***PREFERRED PROJECT AND
RESPONSE TO SUBMISSIONS REPORT***

CROOKWELL 3 WIND FARM

March 2014

MAJOR PROJECT APPLICATION NUMBER (MP 10_0034)

HISTORY PLAN - C3 EAST
FIGURE 4

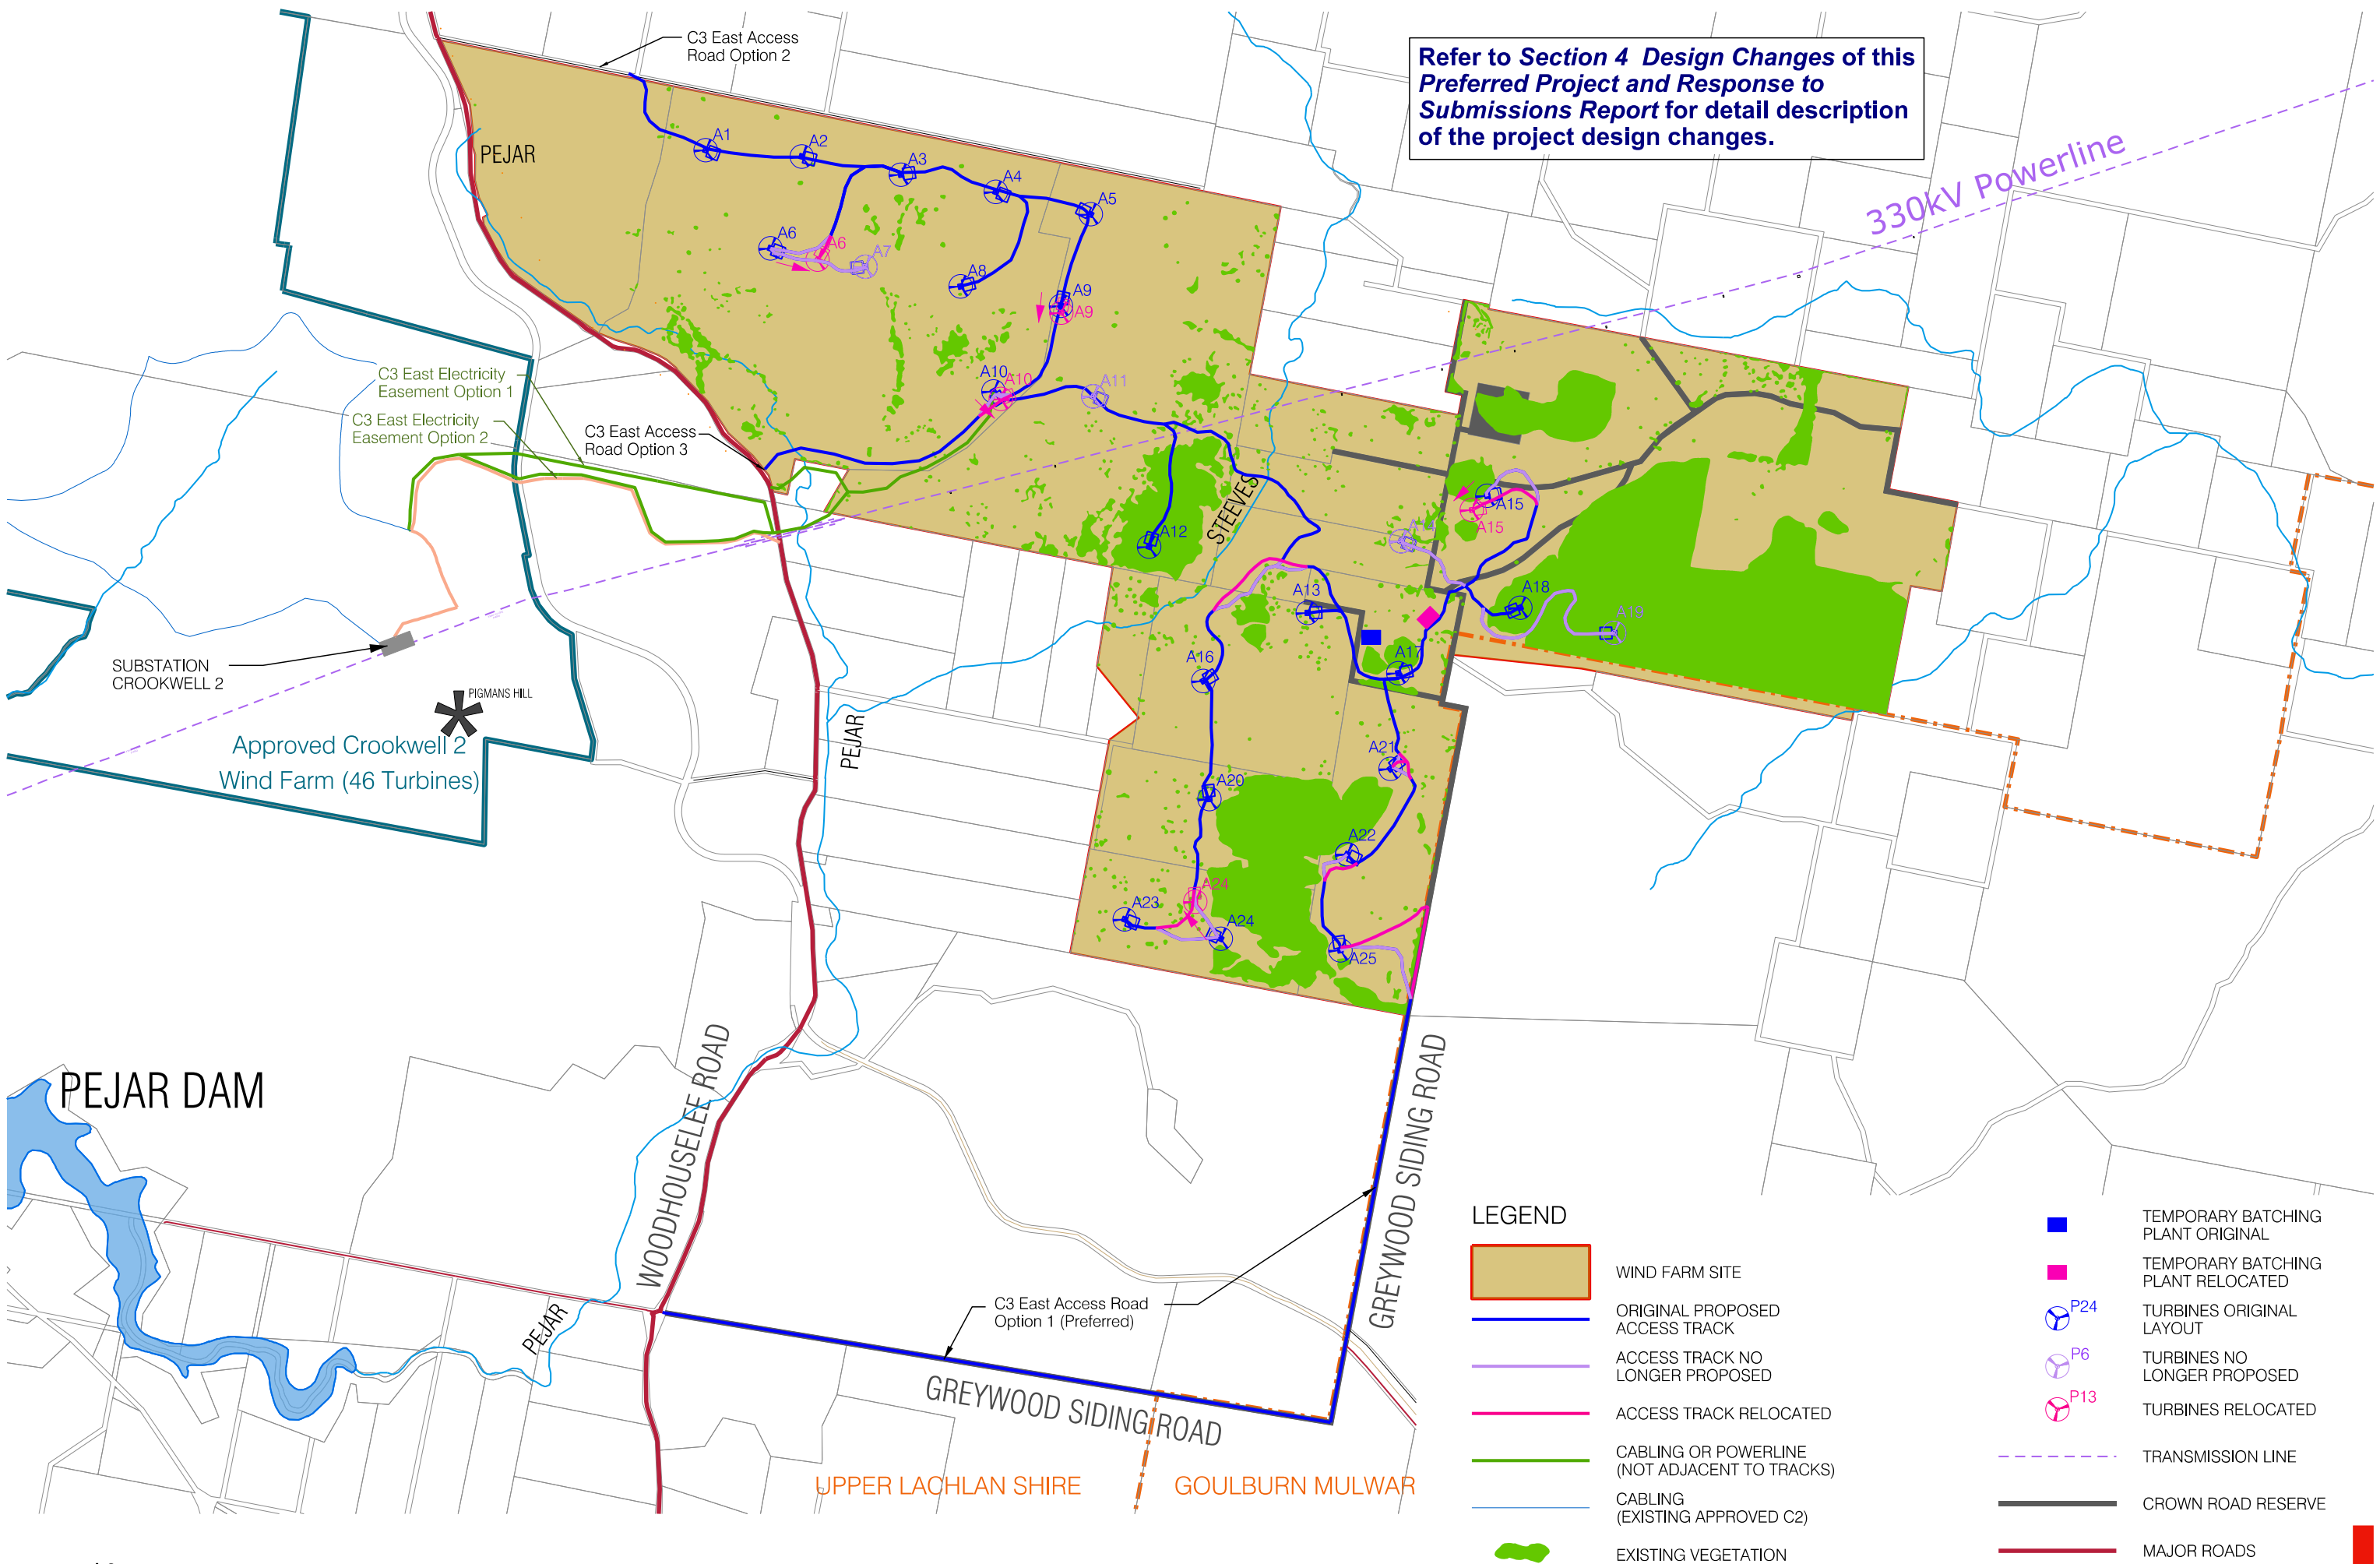
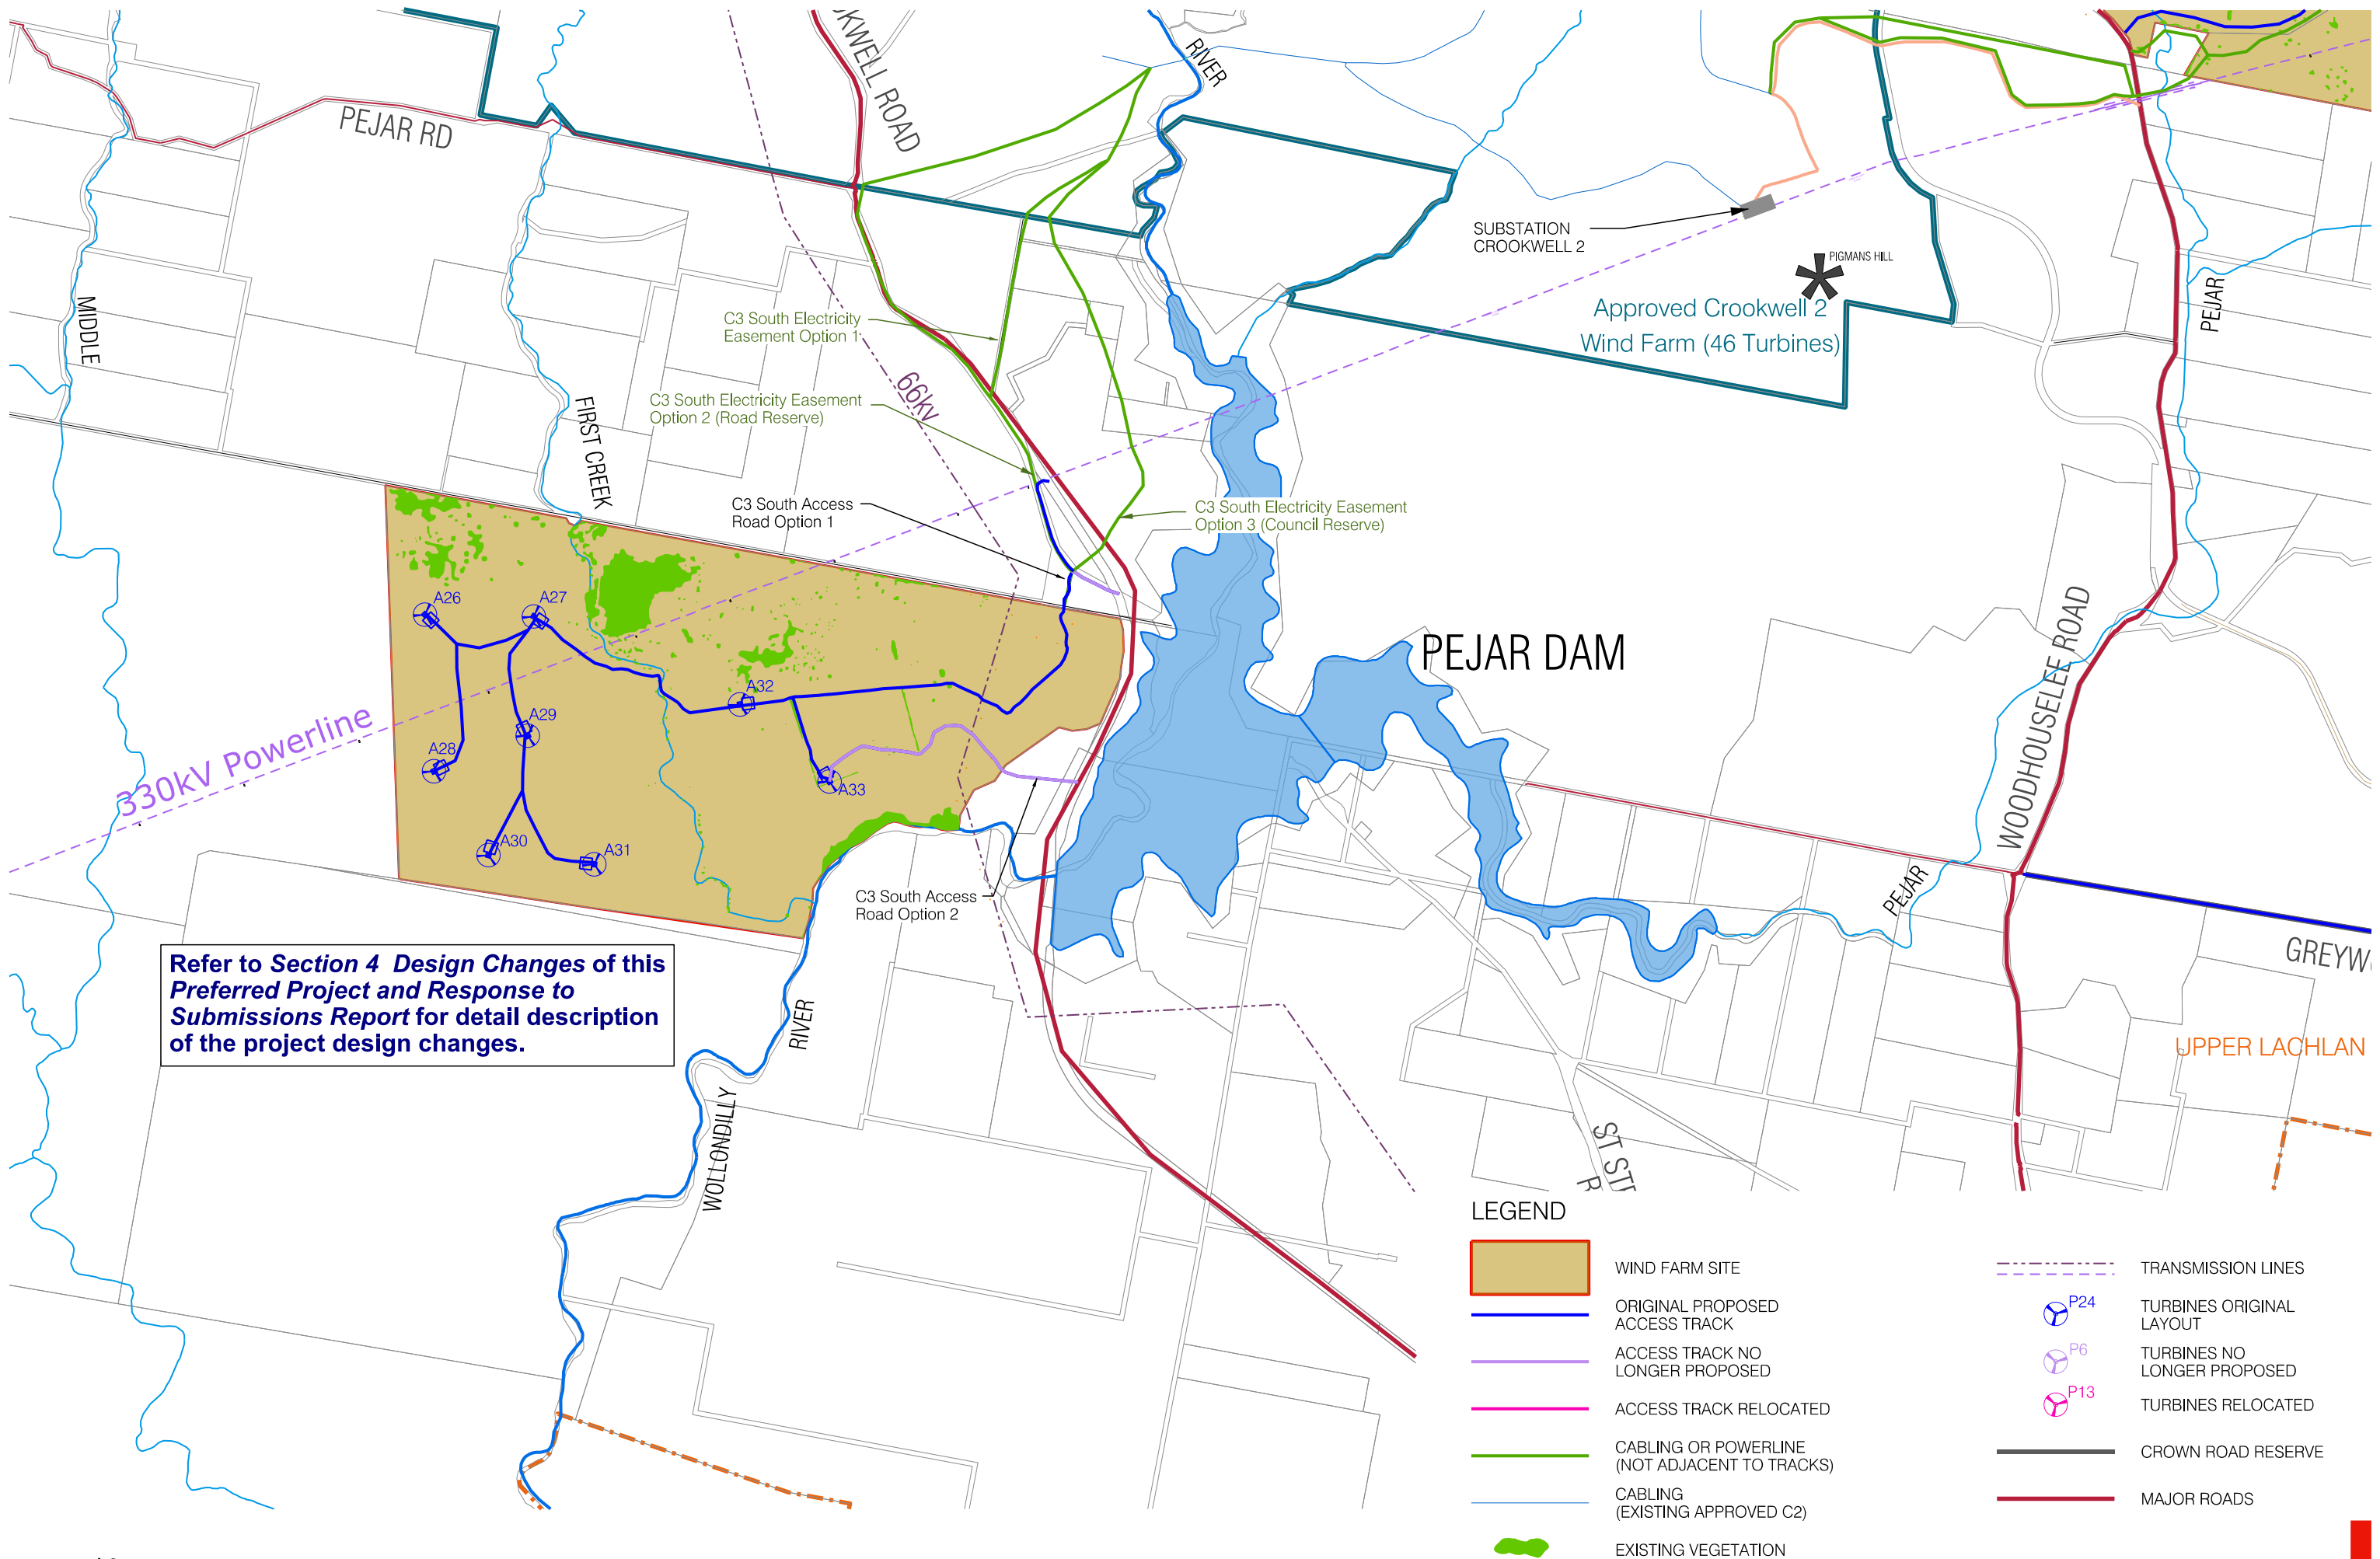
- removing turbine A19 from the publically exhibited layout as a precautionary measure so as to reduce potential impact to the remnant area by avoiding further fragmentation;

The project design changes are shown in *Figure 4 - History Plan - C3 East* and *Figure 5 - History Plan - C3 South*.
